September 28, 2023  
(Revised November 7, 2023)

**Re: Farm Road Homes Residential Development – Comprehensive Permit  
Engineering Peer Review – Traffic  
55-65 Farm Road  
Sherborn, MA**

Farm Road Homes Residential Development  
Engineering Peer Review - Traffic  
55-65 Farm Road  
November 7, 2023 Review Letter

Figure 8B-6. Example of Placement of Warning Signs and Pavement Markings at Grade Crossings  
*Manual on Uniform Traffic Control Devices (MUTCD); Federal Highway Administration; Washington, D.C.; 2009.*

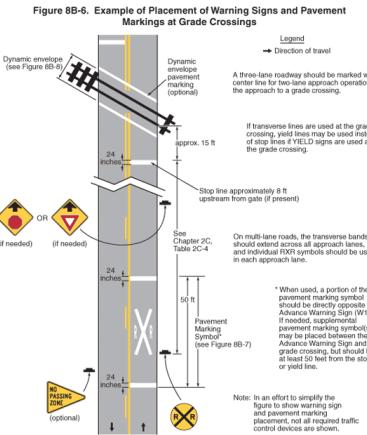
*An inventory of the traffic control devices at the at-grade railroad crossings of Route 27 and Farm Road was completed in October 2023. Based on this inventory, the following recommendations are offered and should be considered independent of the Project:*

- Refresh the stop-line and RXR pavement markings with high visibility thermoplastic markings
  - Relocate/install railroad crossing warning signs (W10-1) opposite the leading edge of the RXR pavement markings and positioned 100 feet from the centerline of the stop-line on the approach to the rail crossing.
  - Consider installing a side street rail crossing warning sign (W10-4) for motorists exiting the south driveway that serves 19 North Main Street.
